# MANDATORY SERVICE BULLETIN

## NO. MSB-42-006/1

Exchange of the Safety Walk on the Wing Stubs.

13		2 x		D60-1127-10-51 Rev "a" or later Issue		Safety Walk					
Pos.		Stk.		Teile Nr.:		Benennung		Orientierung/Abmessung		Lieferant/Bemerkung	
Freigabe :				Geprüft :				Freimaßtoleranz :			
Datum				Name		Datum		Name

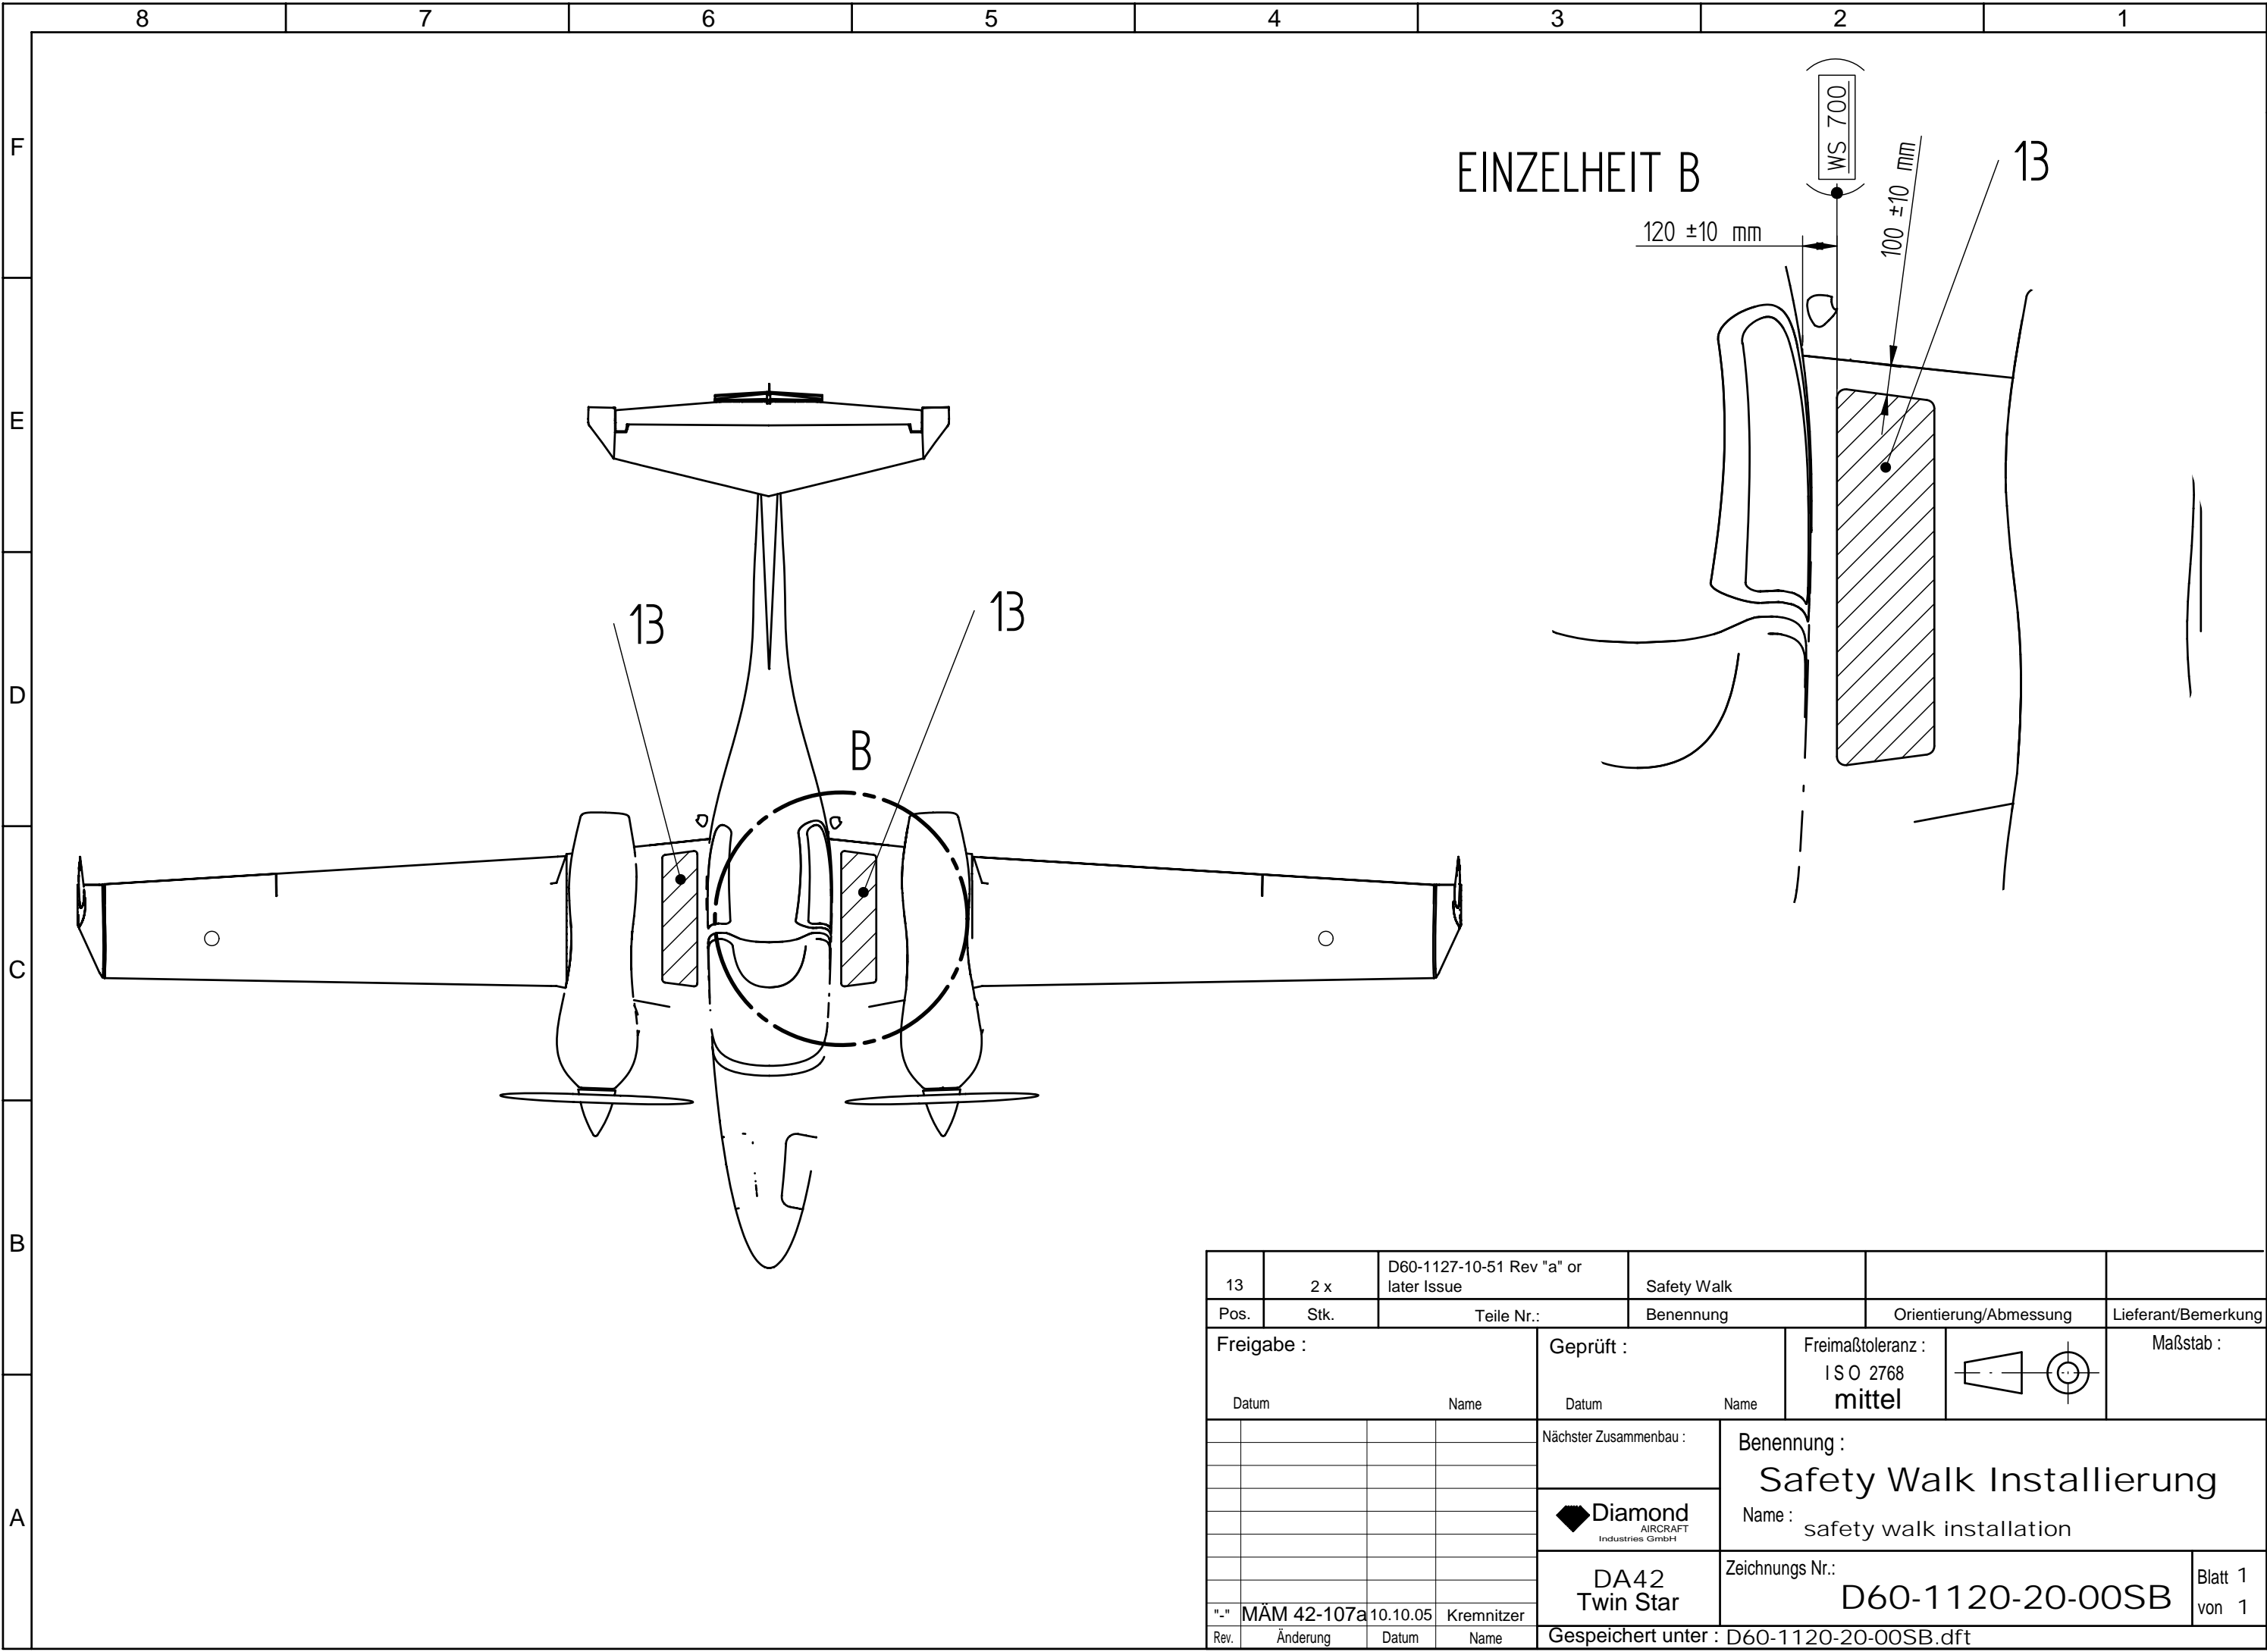
- a Remove Safety Walk Series 300, color grey – coarse surface (surface roughness equal to sandpaper with grid 40). For replacement refer to AMM, Chapter 11-00.
- b Install new Safety Walk D60-1127-10-51 Rev. “a” or later issue (surface roughness equal or finer than sandpaper grid 100) according to drawing D60-1120-20-00SB, latest effective revision. For replacement refer to AMM, Chapter 11-00.
- c Remove AFM-TR-MÄM-42-070, page 5-18a, and AFM-TR-MÄM-42-103, page 5-18b.
- d Mark AFM page 5-18 as superseded.
- e Incorporate Temporary Revision TR-MÄM-42-111/a into the AFM.
- f MSB 42-005 becomes obsolete with compliance to MSB 42-006/1 or later.
